SERVICE BULLETIN

DATE: 05 APRIL 2006

DIRECTIONAL PEDAL ASSEMBLY MODIFICATION

Service Bulletin SB900-100, Directional Pedal Assembly Modification

Figure 1. Pedal Assembly Removal / Installation

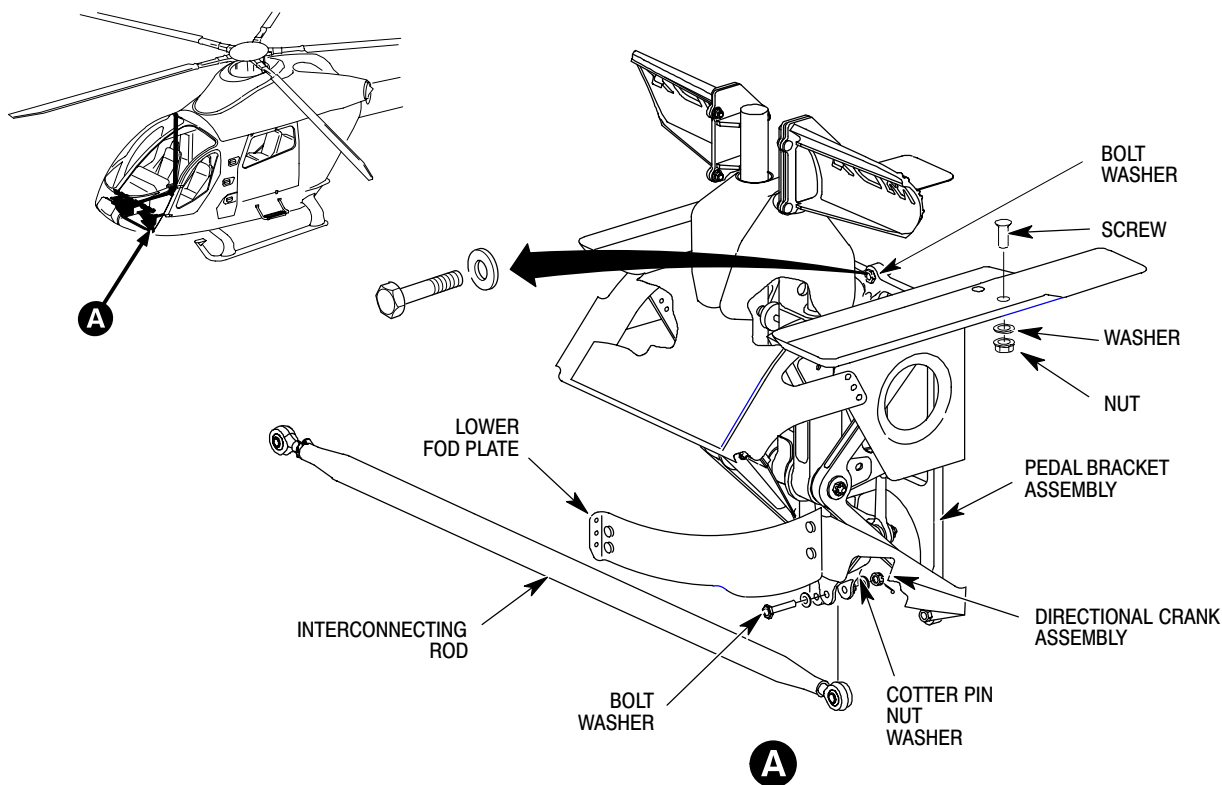
- (2). Remove pedals (Ref. CSP-900RMM-2, Section 67-20-00, Directional Control Pedals Removal).
- (3). With 206E/207E Engines: Remove pedal potentiometer (Ref. CSP-900RMM-2, Section 67-20-00, Potentiometer Removal).
- (4). Remove and retain directional control pedals and attaching hardware (Ref. Figure 1).
 - (a). Remove cotter pin, nut, bolt and washers securing interconnecting rod to lower directional crank assembly.
 - (b). Remove hardware securing pedal bracket assembly and lower FOD plate.
 - (c). Remove sealant from around pedal bracket assembly.
 - (d). Remove complete pedal assembly and lower FOD plate from aircraft.

- (11). Touch up paint as required.
- (12). Reinstall directional control pedals and attaching hardware (Ref. Figure 1).
 - (a). Prepare mating surfaces of directional control pedal mount and mounting bulkhead for class "L" electrical bond (Ref. CSP-SPM).

- (b). Position complete pedal assembly and lower FOD plate in aircraft.
 - (c). Install hardware securing pedal bracket assembly and lower FOD plate.
 - (d). Install bolt, washers, nut and cotter pin, securing interconnecting rod to lower directional crank assembly.

- (e). Test directional control pedal mount for class "L" electrical bond (Ref. CSP-SPM).
 - (f). Apply a fillet of sealant (C216: Ref. CSP-SPM, Section 91-00-00), per manufacturer's instructions, around directional control pedal mount where it mates with mounting bulkhead.

Figure 2. Directional Pedals Modification

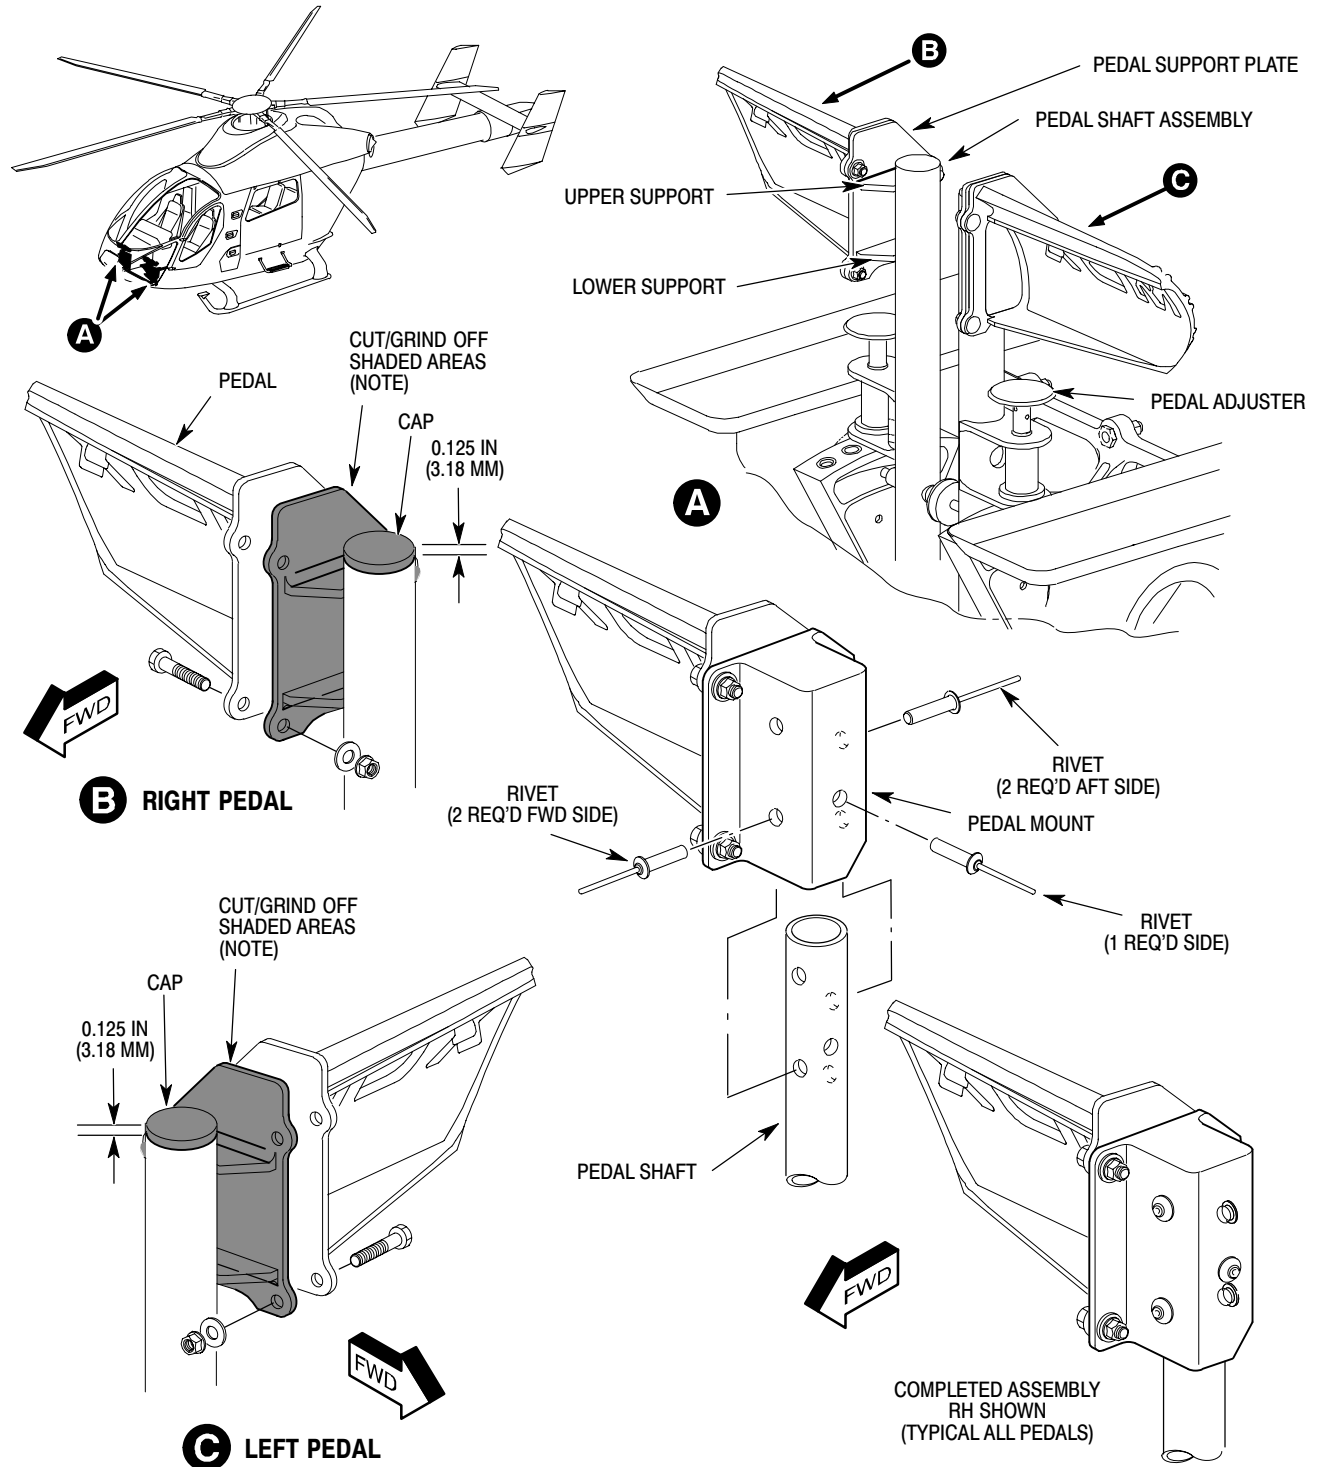
MD Helicopters, Inc. (MDHI) has received a report of a directional pedal separating from the pedal shaft assembly in the area of the welds at the pedal support plate and the upper and lower pedal supports.

Procedures in this Bulletin provide owners and operators with information pertaining to modifying the Directional Pedal Assemblies by removing the existing pedals, removing the welded pedal support plate from the pedal shafts, installing a new pedal mount on the pedal shafts with rivets and reinstalling the pedals on the new pedal mounts.

- (5). Modify each pedal shaft assembly (Ref. Figure 2).
 - (a). Remove support plate by cutting through upper and lower supports.
 - (b). Cut off welded cap, top 0.125 in. (3.18 mm) of pedal shaft.

When grinding off remainder of upper and lower support, do not grind into base metal of pedal shaft.

- (c). Grind off remainder upper and lower supports to allow new pedal mount to slip on pedal shaft. A slight interference fit is allowable.
 - (d). Vacuum shavings from pedal assembly.
- (6). Install pedal mounts (Ref. Figure 2).
 - (a). Ensure both pedal adjusters are in the same adjustment holes.
 - (b). Insert rig pin through mount bracket and pedal shafts.
 - (c). Securely clamp pedal shafts to align evenly with each other.
 - (d). Temporarily install left pedal mount (P/N 900C2010073-101) on left pedal shaft assembly and right pedal mount (P/N 900C2010073-102) on right pedal shaft assembly.
 - (e). Align pedal mounts evenly and secure both pedal mounts with clamping device.

NOTE: DO NOT GRIND INTO BASE METAL OF PEDAL SHAFT.

- (f). Match drill forward and aft rivet holes in mount through one wall of each pedal shaft and cleco in place.
 - (g). Remove clamping devices from pedal shafts and pedal mounts.

- (h). Move pedal shafts to allow for access to inboard sides of pedal mounts.
 - (i). Match drill one inboard rivet hole in mount through one wall of each pedal shaft.

- (j). Ream holes to 0.256-0.261 in. (6.5024-6.6294 mm).
 - (k). Remove pedal mounts, deburr and clean debris from inside pedal tubes and pedal assembly.

- (l). Treat bare metal with alodine.
 - (m). Install pedal mounts on pedal shaft and secure each mount with five rivets wet with primer.
 - (n). Apply a fillet of sealant (C216: Ref. CSP-SPM, Section 91-00-00), per manufacturer's instructions, around pedal mount where it mates with pedal shaft assembly.
